PCN – Process Change Notification

Change:	OMB.450.B06F21
Date:	2016/07/12
Author	Kim Ho

Model#	Part Number	Changes
450MHz 6dBi Omni Antenna with N Type Female ,U-Bolt 1473mm Length Ø70*55mm	OMB.450.B06F21	Amend Aluminium tube brackets.
		Amend length.

Old drawing

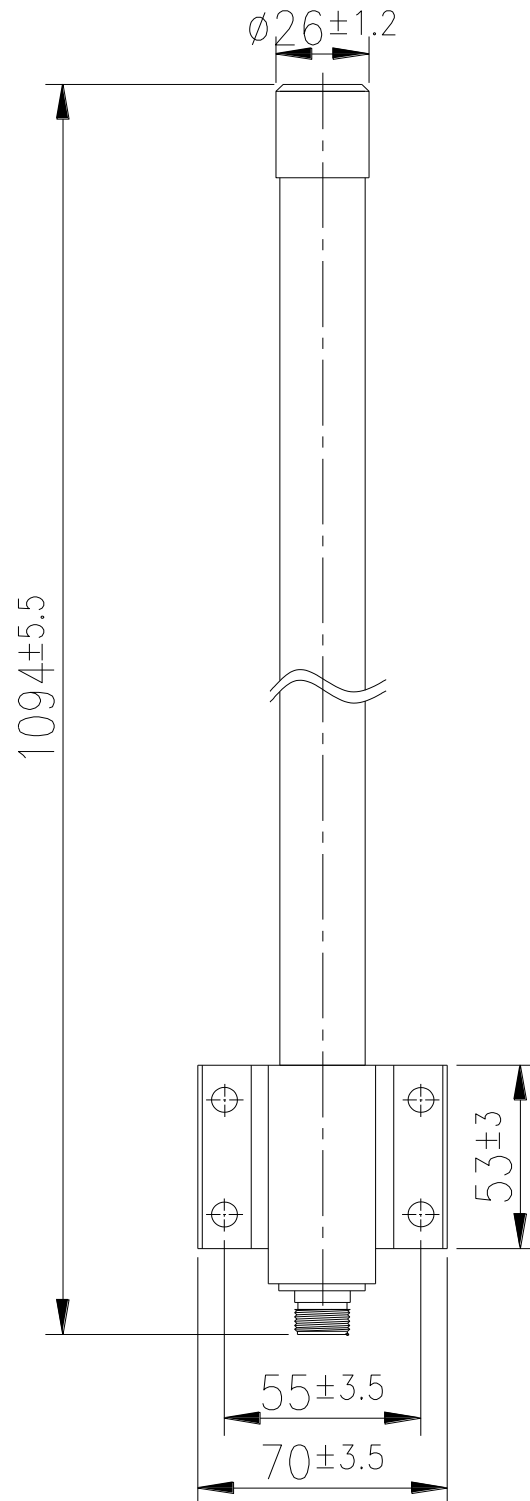
1. Due to antenna performance, Aluminium tube brackets size need to amend from 53mm to 73mm, also change length from 1094mm to 1473mm.
